WPA Form 3 - Notice of Intent

"PROPOSED  
CARWASH  
IMPROVEMENTS, 565  
& 569 AMERICAN  
LEGION HIGHWAY,      KEVIN SOLLI, PE      KEVIN SOLLI, PE      June 1, 2021      1"=20'  
ROSLINDALE,  
MASSACHUSETTS -  
PERMITTING PLAN  
SET"

**RE: Response to Comments  
Notice of Intent  
Proposed Carwash Improvement  
565 & 569 American Legion Highway  
Roslindale, Massachusetts**

Please see our response to the comments issued via email on June 23<sup>rd</sup>, 2021 by Kate Oetheimer with the Boston Conservation Commission. A response to each comment is provided in **bold** where applicable.

Sheet Title: LANDSCAPING PLAN Sheet #: 2.61

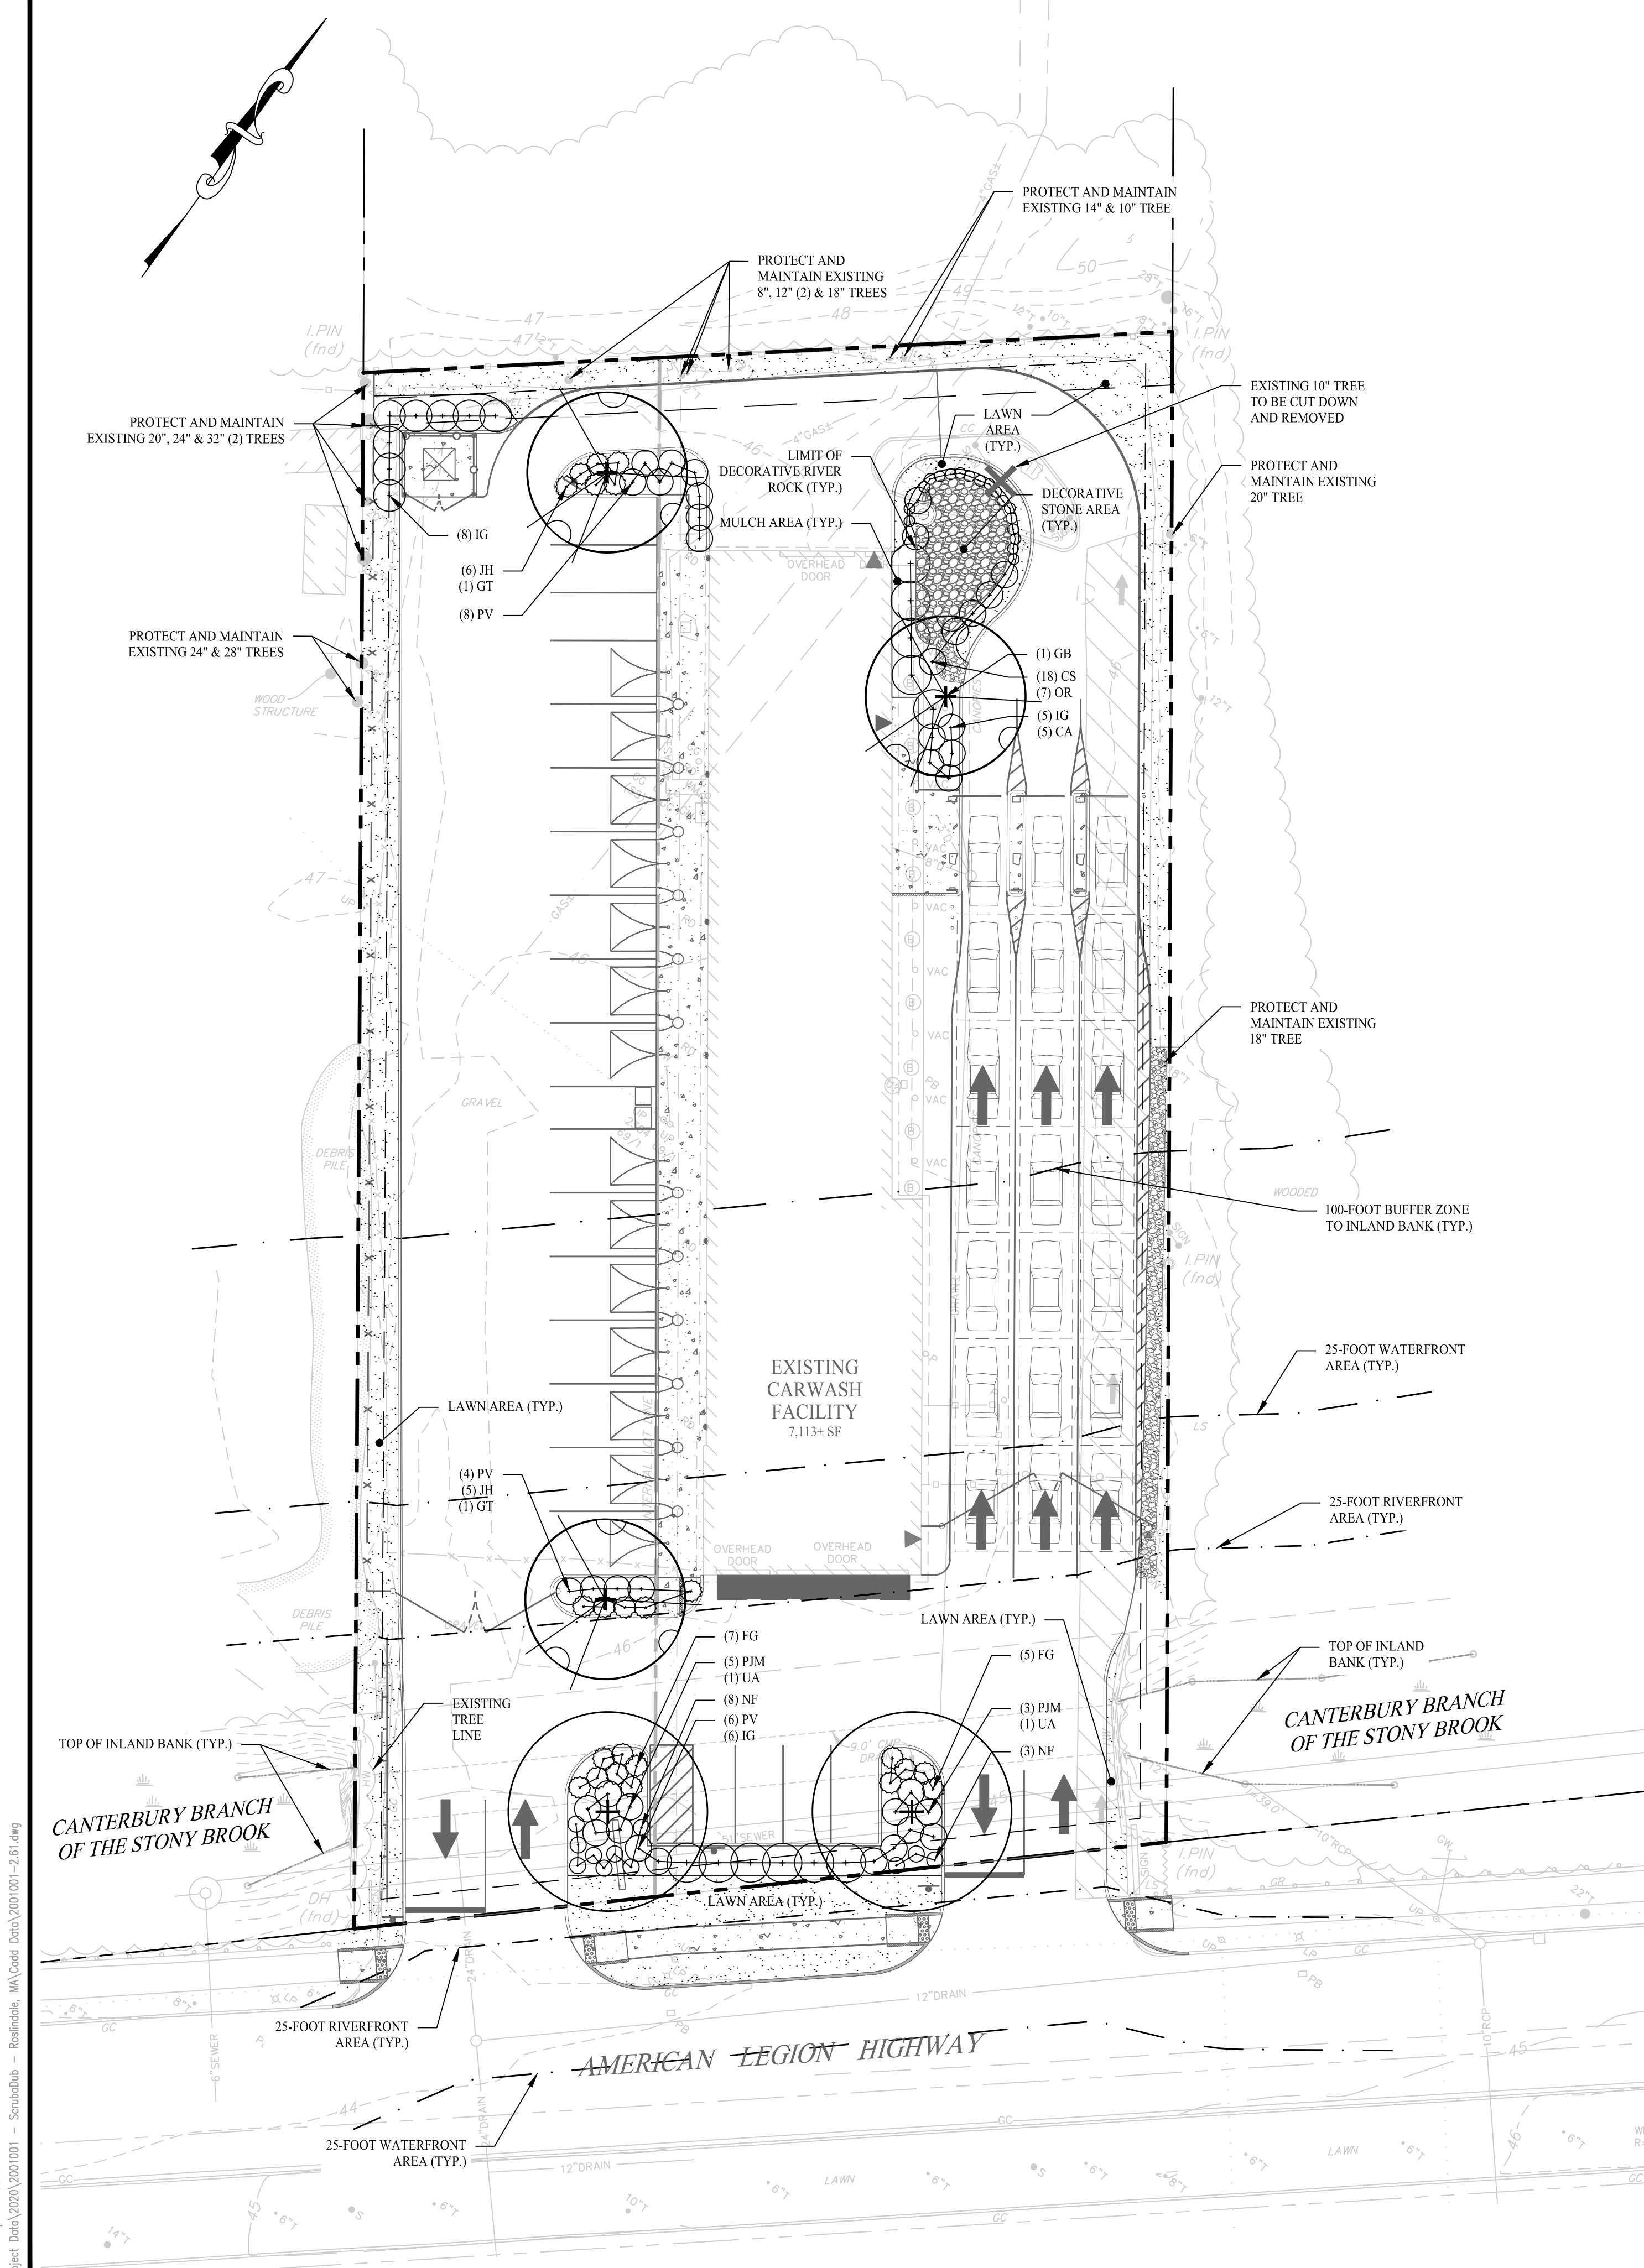
9. We noticed that no trees were indicated on the plan set. Are there any trees with a DBH of 6 or more within the property boundary? If so, please note them on the plans as well.

**Yes, all existing trees are indicated on the “Existing Conditions Plan” as well as in the background of all other plans. The trees are indicated with a shaded circle and a text that states X” T, representing blank-inch tree. All on-site trees that are to be protected and maintained or cut down are called-out on the Soil Erosion and Sediment Control Plan (Sheet 2.31).**
